Supporting Material for 802.1AS D6.1 Ballot Comments 35, 36, 37, and 80

Geoffrey M. Garner
SAMSUNG Electronics (Consultant)

IEEE 802.1 AVB TG
2009.09.08

Figure B – 4. Wander MTIE masks

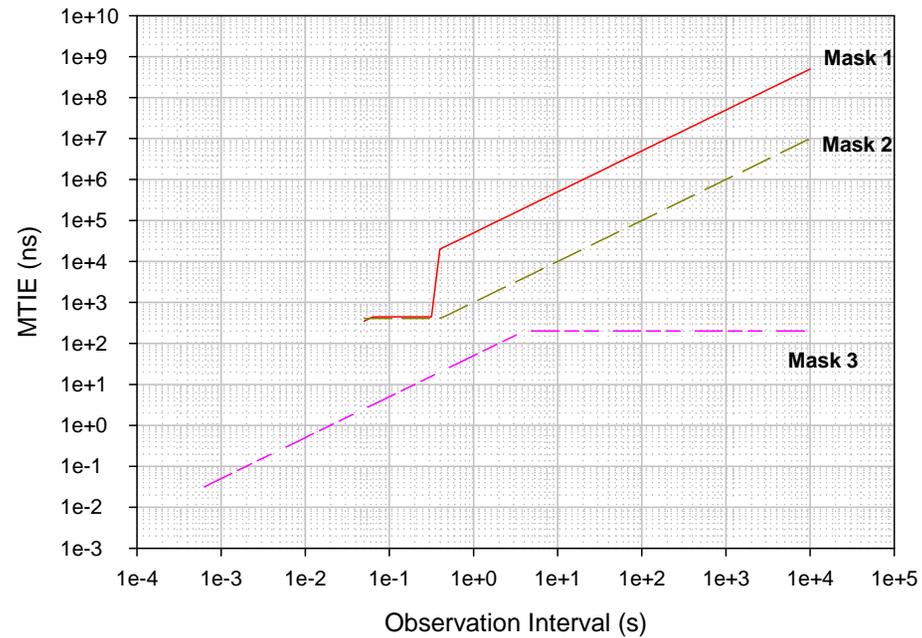
- B.3 states that the requirements of this standard and of standards referenced for each medium enable a time synchronization requirement of 1 μ s (+/- 500 ns) over 7 hops to be met. It would be useful to make a similar statement for jitter/wander requirements.

- Add a subclause to annex B entitled "End-to-end jitter and wander performance". Suggested text, and an accompanying figure and table, are on the following slides.

The requirements of this standard and standards referenced by this standard ensure that the synchronized time at a time-aware system that is separated from the grandmaster by six or fewer time-aware systems (i.e., seven or fewer hops) will, when filtered by a reference endpoint filters with rolloff of 20 dB/decade, gain peaking that does not exceed 0.1 dB, and bandwidth that does not exceed the value given in each entry of Table , have wander maximum time interval error (MTIE) that does not exceed the maximum time interval error (MTIE) for that entry of Table B-4, and jitter that does not exceed the peak-to-peak jitter of Table B-4.

Table B-4 – Maximum endpoint filter bandwidths needed to meet respective MTIE masks

Endpoint filter maximum bandwidth (Hz)	Corresponding wander MTIE mask of Figure B-4 that is not exceeded	Corresponding jitter high-pass measurement filter (Hz)	Corresponding peak-to-peak jitter (ns)
10	Mask 2	8000	10.2
1	Mask 1	200	11.1
0.01	Mask 3	–	–

**Example Clock Phase Noise Specification
Provided in [7] (data in [7] does not extend
above 10 kHz; PSD is assumed flat for higher
frequencies with the 10 kHz value)**

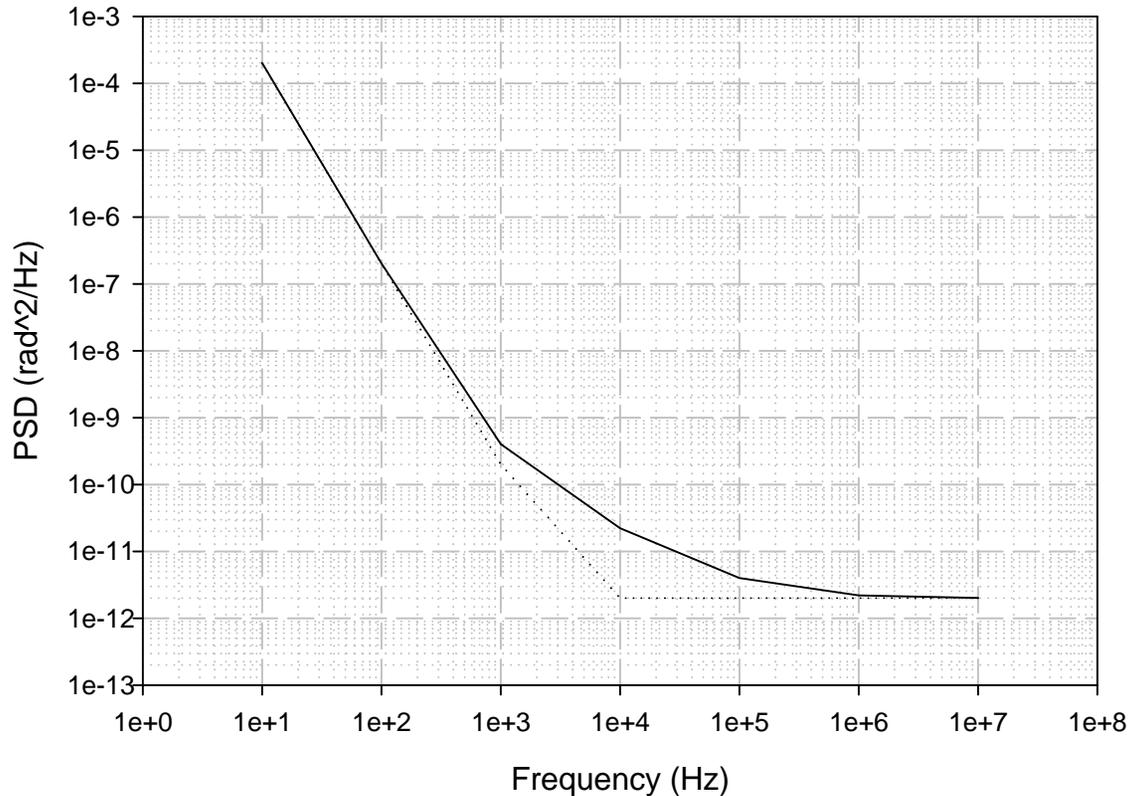
- ❑ The plot on slide 21 indicates that, between 10 Hz and 12.5 MHz, the FFM is the dominant noise component
- ❑ The comment indicates that the jitter was incorrectly computed using the WPM component
 - The resulting rms jitter was considerably less than 1 ns; this was rounded to 1 ns, which is still very small compared to the 40 ns phase measurement granularity
- ❑ In any case, the above is incorrect; we now compute the jitter due to each component

Network Interface MTIE Masks for Digital Video and Audio Signals

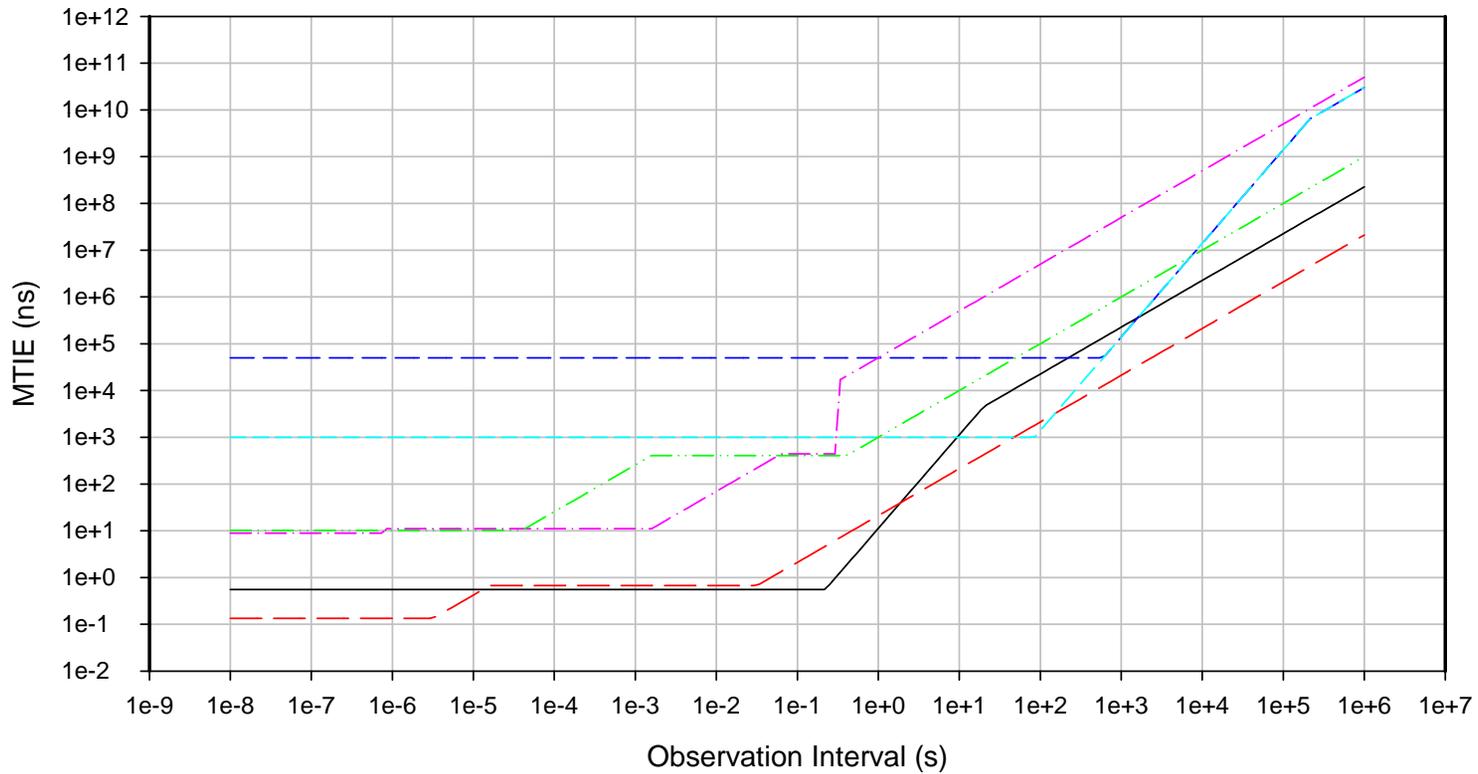
- ❑ In summary, the following items must be resolved
 - What should the high-pass jitter measurement filter bandwidth be?
 - Should the spec be on peak-to-peak or rms jitter?
 - What should the jitter limit be?
- ❑The answers to these questions will depend on
 - What do we assume for the magnitude and type of phase noise?
 - What is practical for existing test equipment?
- ❑It is likely desirable to not have the jitter measurement filter corner frequency too high, as the higher-frequency jitter is easily filtered by endpoint filters and won't impact the jitter seen by the application timing appreciably
 - This means we should consider the MTIE masks for the various applications
- ❑They are reproduced on the following slides

- ❑ The uncompressed video masks have a corner frequency of 10 Hz
- ❑ The uncompressed SDTV mask has the equivalent of a corner frequency at 1 – 2 Hz due to the frequency drift requirement
- ❑ Both masks have peak-to-peak limits that are less than 1 ns
 - However, we have sent a liaison to SMPTE asking about the applicability of these requirements
- ❑ The audio masks have corner frequencies of 200 Hz (consumer) and 8 kHz (professional), with peak-to-peak limits around 10 ns
- ❑ Note that if we know the noise type, or make a conservative assumption, then we can choose a measurement filter with corner frequency greater than 10 Hz but still constrain the jitter from 10 Hz to 12.5 MHz
